# FOR BOARD ACTION

**SUBJECT:** Change Order to Purchase Order #10219  
Power Generation Services  
SLP Unit 4 Turbine Generator Overhaul

**2006 - SLP Unit No. 4 Turbine Generator  
Overhaul Cost Matrix**

To: Wally Schlink and Lloyd Lynch, Rochester Public Utilities  
From: Troy Gehrett  
Re: Silver Lake Unit #4 Initial SPA Findings and Recommendations

*Figure 1 – Stage 2 bucket leading edges with FOD*

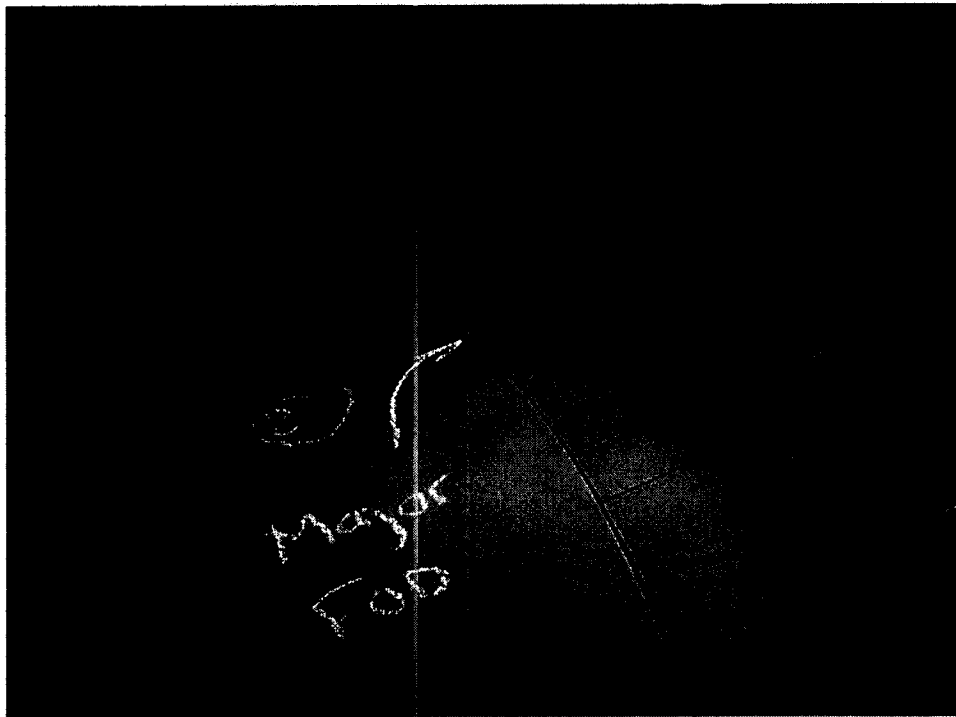
Generally speaking, the unit was found to be in good condition. There were some areas of the unit, however, that showed signs of damage. Most notably, the stages 2 and 3 buckets were badly damaged on the leading edges due to foreign object damage (FOD). Additionally, these buckets had thin leading and trailing edges (see *Figure 1* and *Figure 2* for examples of the damage).

In some cases, moderate amounts of FOD may be repaired through straightening and polishing the leading and or trailing edges of the bucket to restore the proper thickness and inlet/exhaust angles. These buckets are unfortunately too thin on the leading and trailing edges to perform this type of repair. It is recommended that these stages be replaced.

1. Remove and replace the stage 2 buckets
2. Remove and replace the stage 3 buckets
3. Straighten and polish the leading and trailing edges of the stage 4, 5, 6, 8, and 9 buckets to improve their existing condition

*Figure 6 – Spill strip leakage loss breakdown by stage*

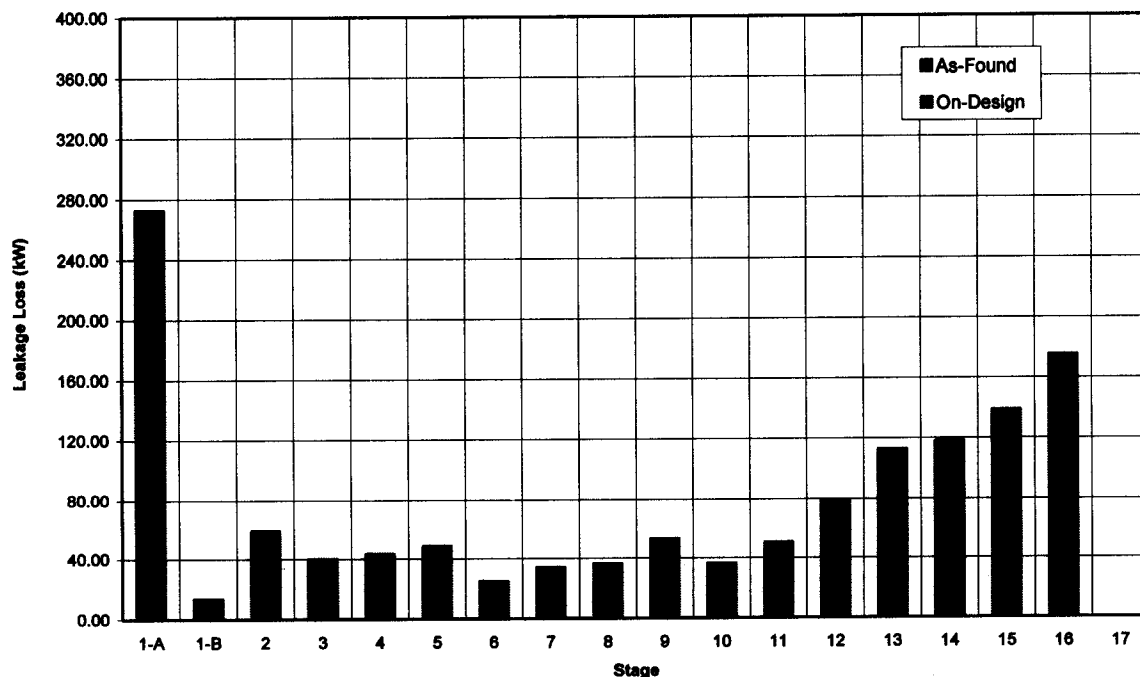
The greatest potential recoverable loss would result from the replacement of all of the spill strips in the unit (see *Figure 6* for details on stage by stage spill strip loss). This is estimated to produce an improvement of 541.14 kW, which is approximately 1.00% of the rated output for the unit. The second largest potential recoverable loss would result from the replacement of the HP gland seals. This would be estimated to account for an improvement of 516.25 kW, which is approximately 0.96% of the rated output for the unit.

- If not repaired during this outage these partitions should be repaired during the next scheduled outage
14. Remove and replace spill strips in all stages of the unit

Figure 7 – Stage 13 diaphragm partitions with heavy build up of deposits

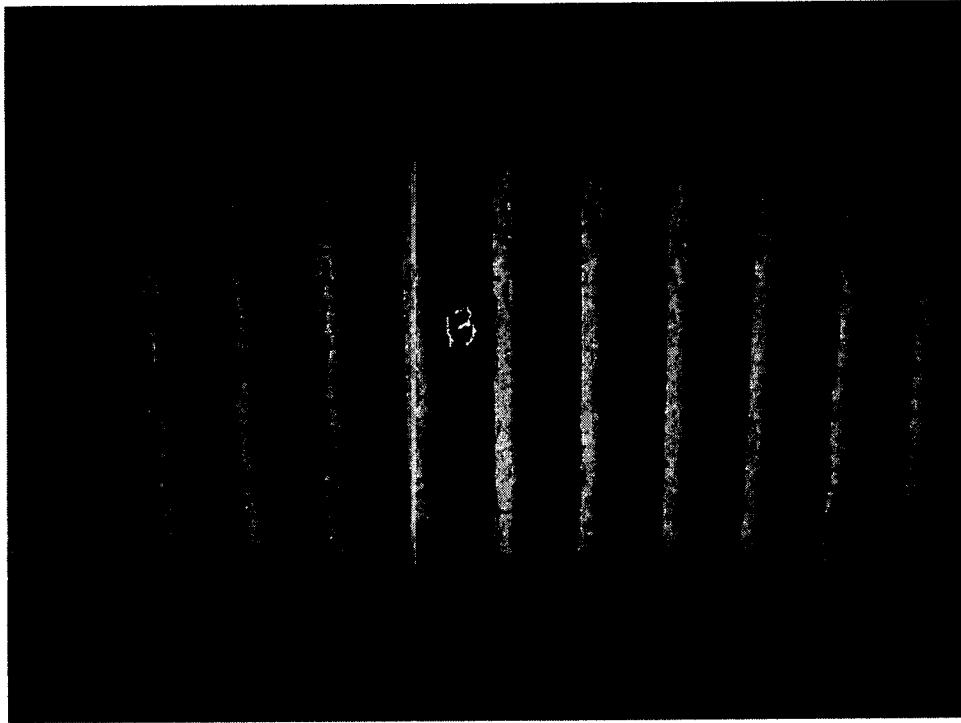
In addition, grit blast cleaning of the diaphragms and buckets is expected to produce a total combined improvement of 231.36 kW, which is approximately 0.43% of the rated output for the unit. However, this calculation does not account for the removal of heavy deposits on the stage 13 and stage 14 diaphragm partitions (see *Figure 7* for examples of the deposits). These deposits, though apparently non-corrosive, substantially impacted the flow of steam from the diaphragm partitions to the buckets. Samples of this deposit were taken from both the stage 13 and 14 diaphragms. It is recommended that this sample

be analyzed to determine its chemistry. It is further recommended that efforts should be made to locate the source of this fouling and reduce or eliminate it.

15. Remove and replace the HP gland packing seals
16. Perform chemical analysis of samples taken from the stage 13 and 14 diaphragm partitions so that the source of this fouling be located and reduced or eliminated
